The New Piper Aircraft, Inc.

# S E R V I C E *No. 1045*

*Inspection of the Forward Wing Spar Attach Bracket*

PA-31, PA-31 -300 Navajo

Inspection of the Forward Wing Spar Attach Bracket  
Figure 1

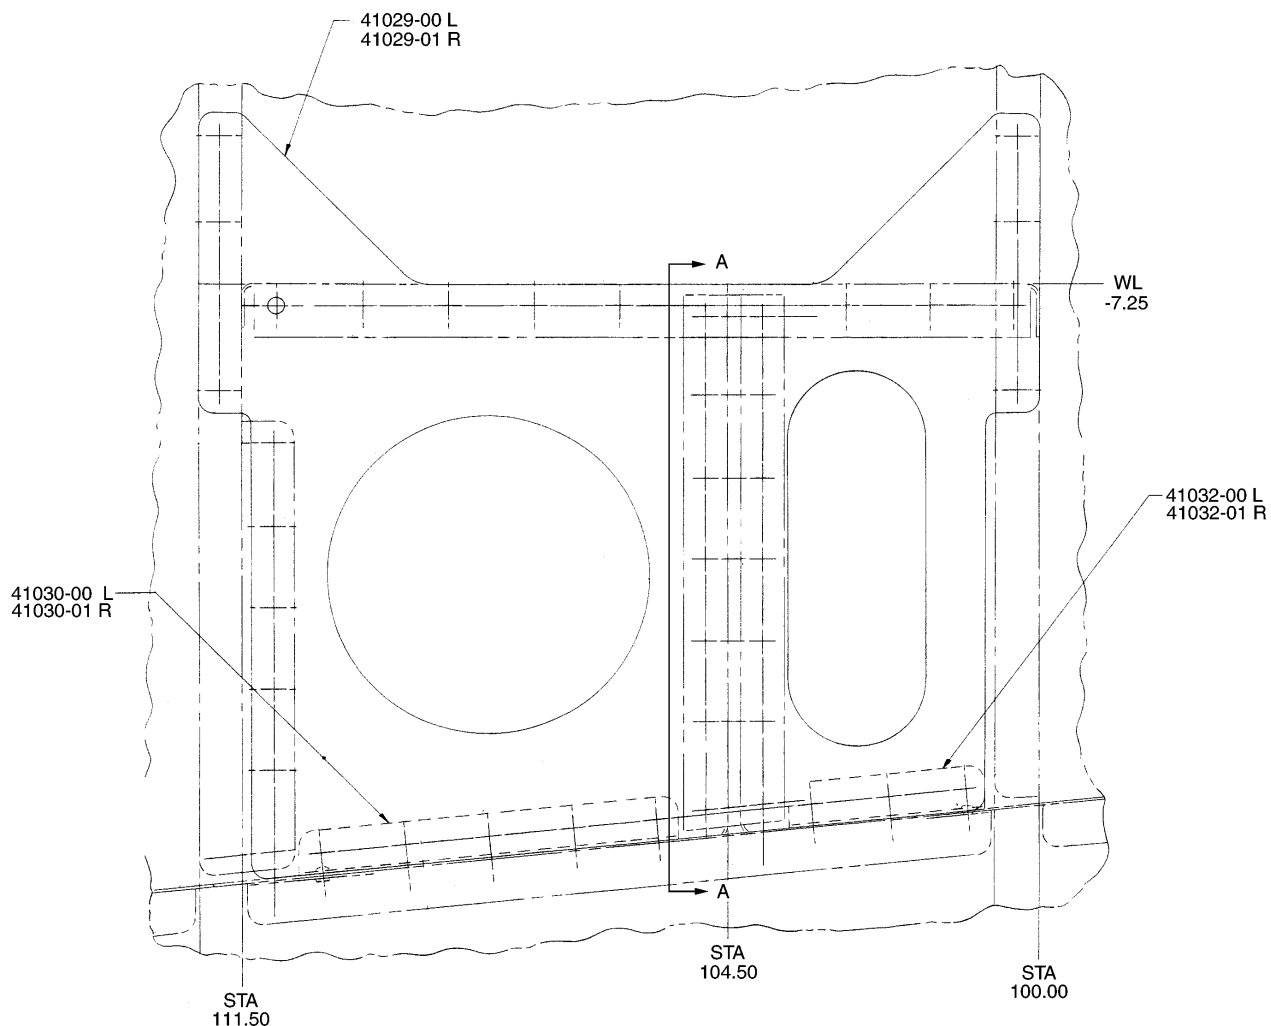
5. Remove the pilot and copilot seats.
6. Remove the interior side panels adjacent to the pilot and copilot seats (FS 100 to FS 135) to gain access to the Front Spar Attaching Bulkhead (FS 104.50). (It may be necessary to remove cabinetry in order to remove the side panels.)
7. Using a light and a 10 power magnifying glass, carefully examine the forward and aft faces of the Left and Right Front Spar Attachment Bulkhead Assembly for cracks, particularly in the outboard flange radius and along the edge of the rivets attaching the flange to the skin.

*The forward face of the bulkhead can be examined through the elliptical hole in the fuselage reinforcement plate, located at approximately FS 102, and the aft face can be examined through the round hole in the fuselage reinforcement plate located at FS 108.*

8. If cracks are found, it will be necessary to remove and replace the complete Left (p/n 41658-00) and/or Right (p/n 41658-01) Front Spar Attachment Bulkhead with a Left (p/n 52694-00) and/or Right (p/n 52694-01) Front Spar Attachment Bulkhead. This will also require replacement of the Left (p/n 40603-00) and/or Right (p/n 40603-01) Front Spar Attach Channel with a Left (p/n 40603-02) and/or Right (p/n 40603-03) Front Spar Attach Channel.

Also if cracks are found, it will be necessary to remove and replace the Left (p/n 41029-00) and/or Right (p/n 41029-01) Reinforcement Plate, the Left (p/n 41030-00) and/or Right (p/n 41030-01) Angle, or the Left (p/n 41032-00) and/or Right (p/n 41032-01) Angle.
